UNITED STATES PATENT AND TRADEMARK OFFICE

10/589,091

Office Action Summary	Application No. 10/589,091	Applicant(s) SCHIERHORN, UWE	
	Examiner JONATHAN KOAGEL	Art Unit 3744

DETAILED ACTION

Ueno Fig. 1

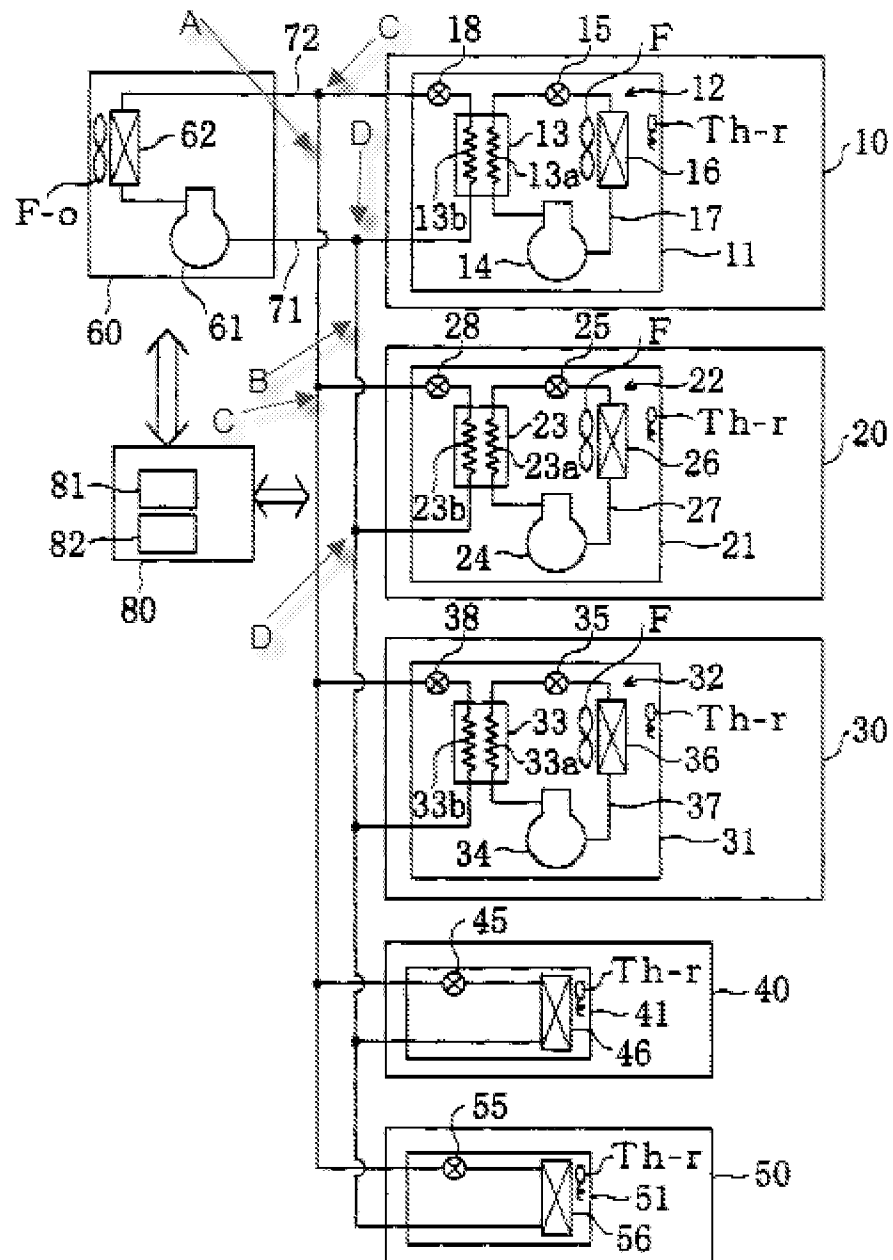
Regarding claim 7, Ueno teaches in fig. 1, a refrigeration installation having at least one refrigeration consumer 10, 20 which includes at least one evaporator 16, 26, having at least one feed line A (See annotated figure below) and at least one discharge line B (See annotated figure below), via which a refrigerant is fed to the at least one refrigeration consumer 10, 20 and discharged from the at least one refrigeration consumer 10, 20, the at least one refrigeration consumer 10, 20 having expansion members 15, 25 wherein, the expansion members 15, 25 being designed as modified expansion valves, each refrigeration consumer 10, 20 being assigned a conventional compressor 14, 24 and the modified expansion valves 15, 25 having a working position that is capable of allowing flow to pass through without a significant pressure drop (column 4 lines 1-11, column 5 line 13-column 6 line 57). Before the operation of the compressor, the modified expansion valves would be in a working position because a pressure drop would not exist within the system. Ueno fails to explicitly teach a compressor with a bypass line.

Regarding claim 9, Ueno as modified above teaches the invention as disclosed and further teaches in fig. 1, wherein a plurality of refrigeration consumers 10, 20 are connected to the at least one feed line A (at point C, see annotated figure above) and the at least one discharge line B (at point D, see annotated figure above). Ueno fails to explicitly teach the connection is by means of couplings.
